# Mechanical Permit Set - Equipment Replacement Puyallup School District Central Kitchen Facility

**CENTRAL KITCHEN FACILITY**  
3607 17th St SW Puyallup, Washington  
SHEET TITLE: **MECHANICAL/ELECTRICAL  
SITE PLAN**  
SHEET NO.: **ME1.0**  
PROJECT NO.: **7351**

**CENTRAL KITCHEN FACILITY**  
3607 17th St SW Puyallup, Washington  
SHEET TITLE  
**1/4" KITCHEN PLUMBING  
PLAN B**

TITLE: PUYALLUP - QUOTE 24092 REV 8  FLOOR PLAN		UNLESS OTHERWISE SPECIFIED:	MODEL NUMBER	REV
		DIMENSIONS ARE IN INCHES AND ARE USED FOR REFERENCE ONLY.  ON-SITE VERIFICATION MAY BE REQUIRED.  DO NOT SCALE.	FLOOR PLAN	A
DATE: 3/14/2025	DRAWN BY: T. AFFELDT			SHEET: 1 OF 3

BATCH COOK CHILL TANK, 200 GALLON

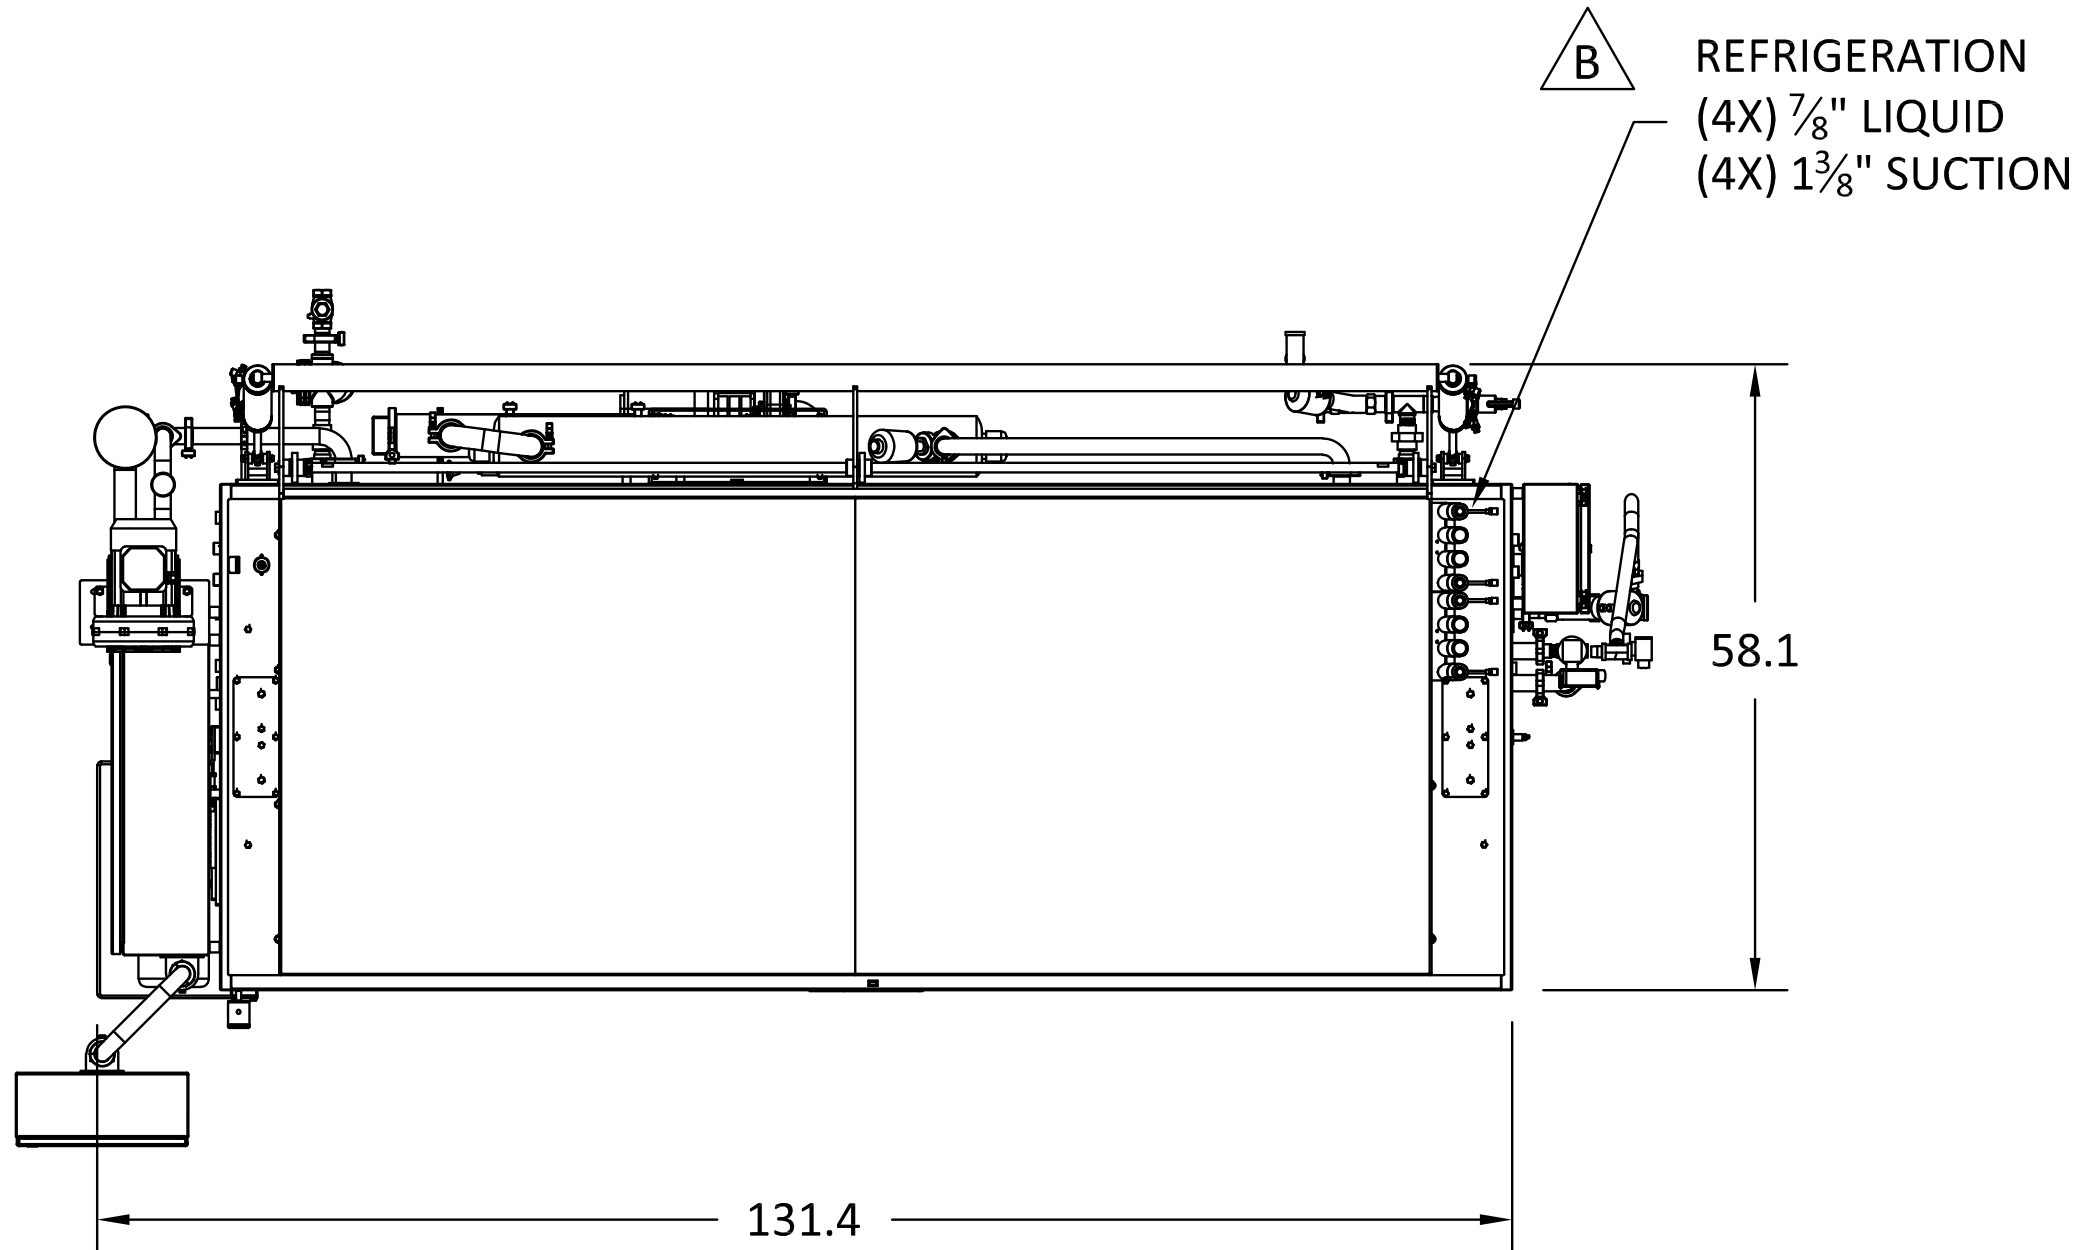
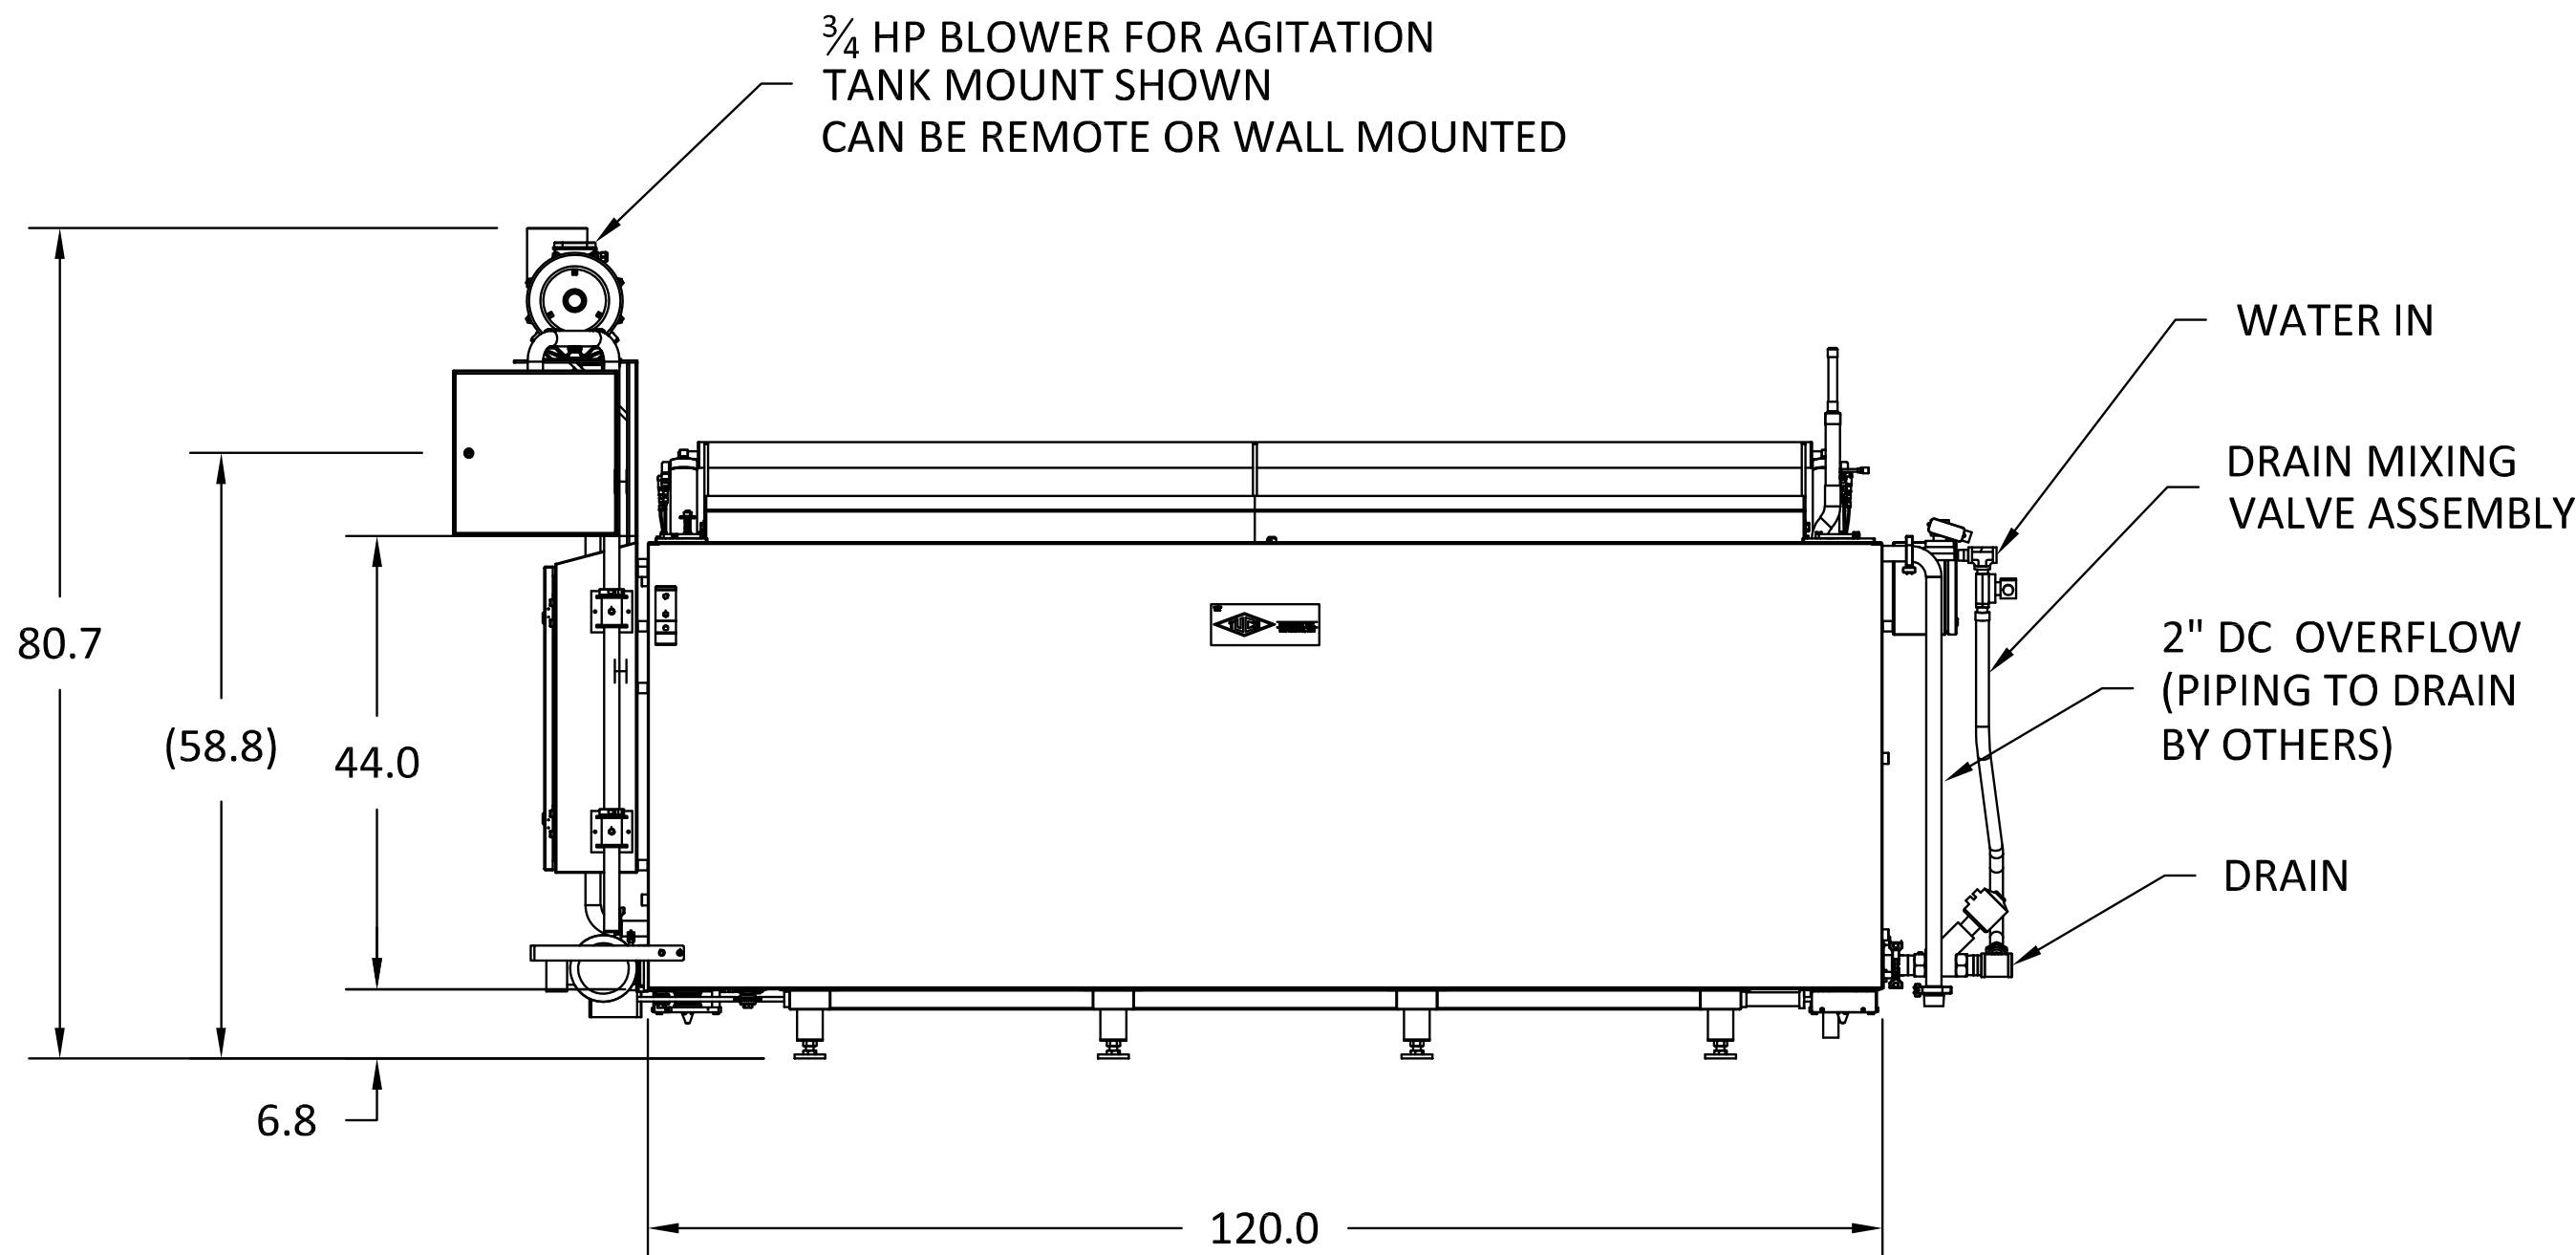
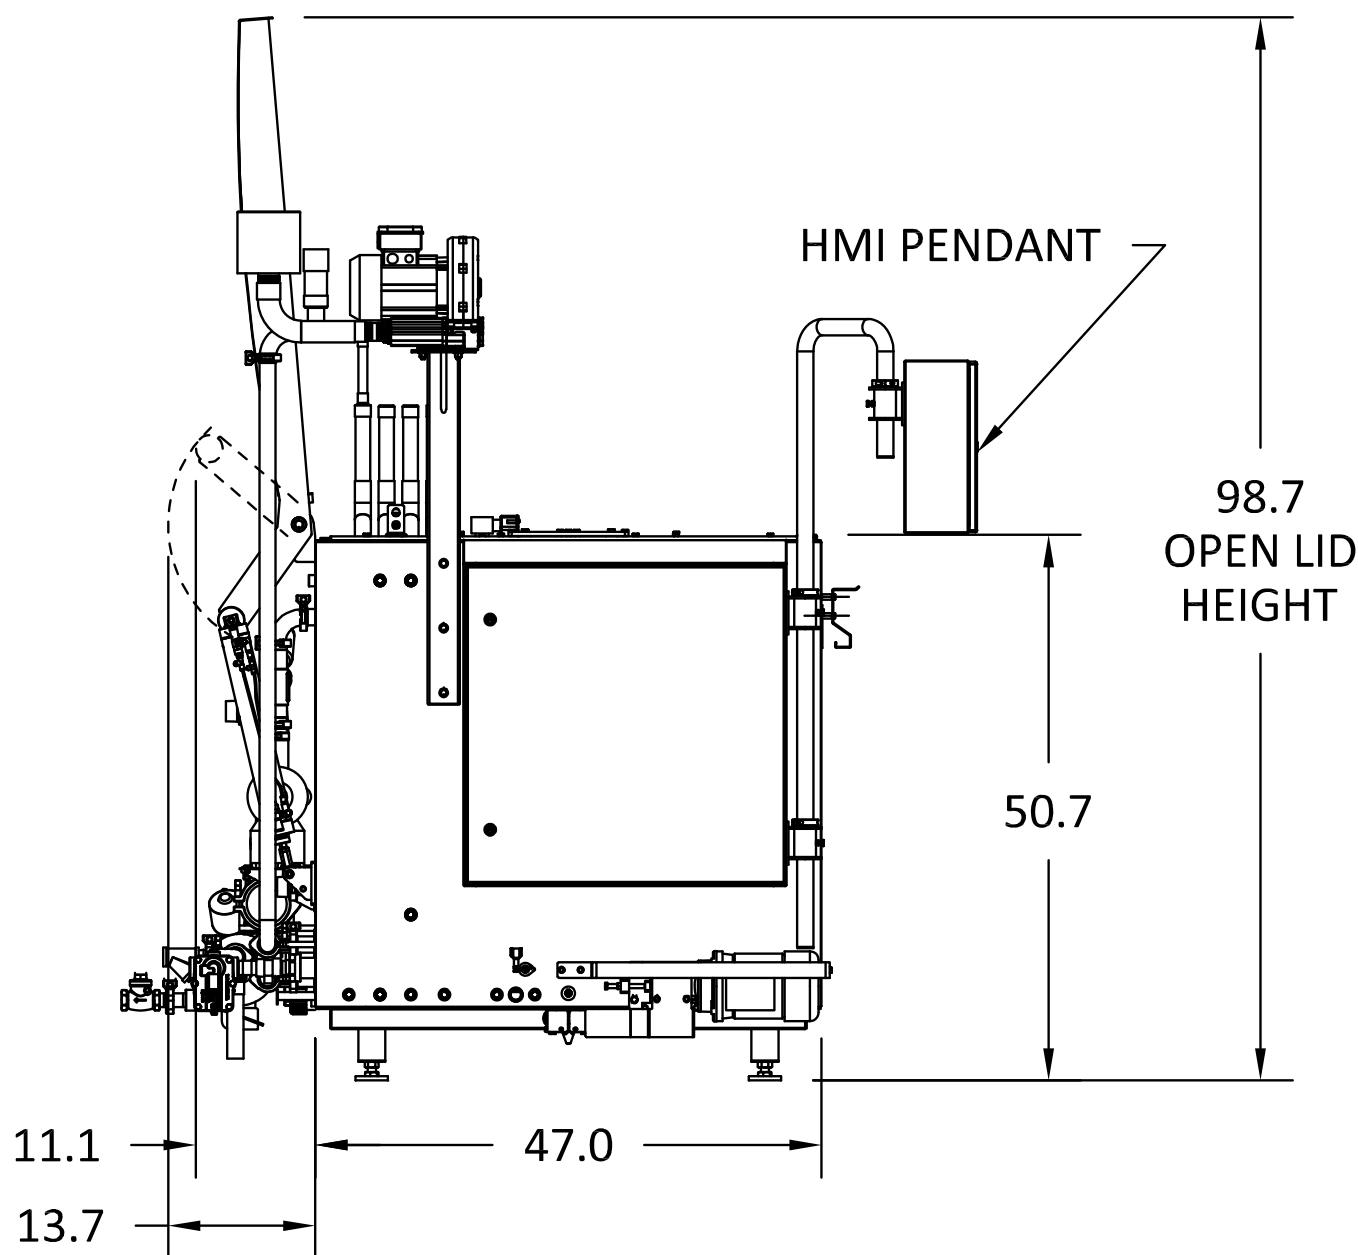
REVISIONS					PRMH20250723
ZONE	REV	DESCRIPTION	DATE	REVISED BY	
	A	RELEASED FOR APPROVAL	3/14/2025	T. AFFELDT	
	B	4X REFRIGERATION CONNECTIONS WAS 2X AND ADDED NOTE 4	4/7/2025	T. AFFELDT
